™Öpaline Head Window Flange Detail

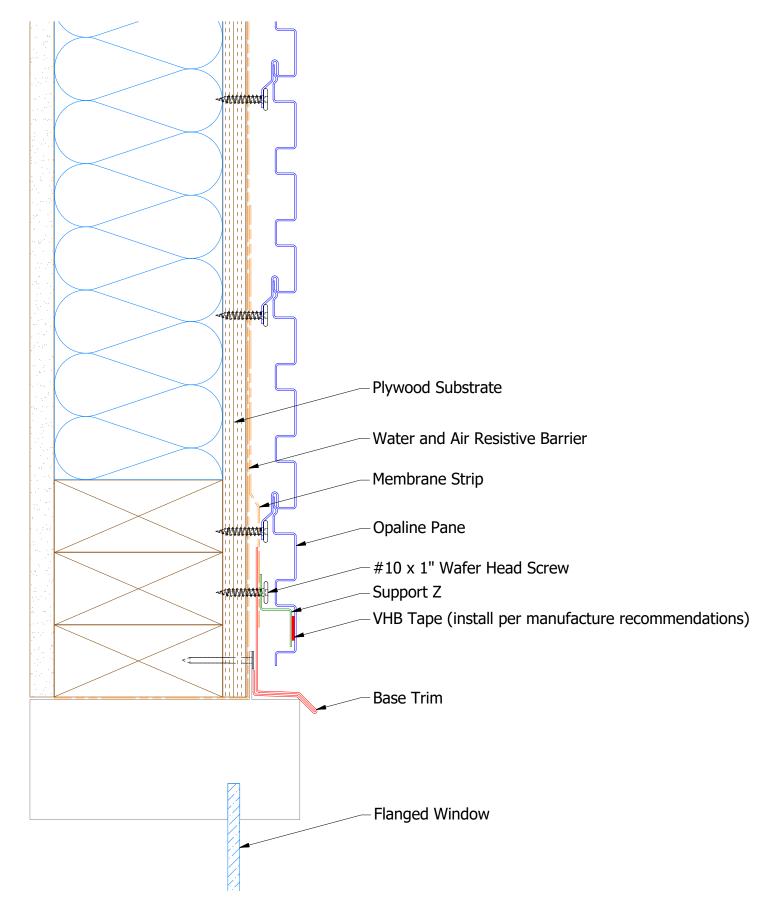
01
 8/30/2021
 Changed Pop Rivet to VHB Tape
 KRK
 MA

Note: stainless steel pop rivets maybe needed along with VHB tape for longer panels.
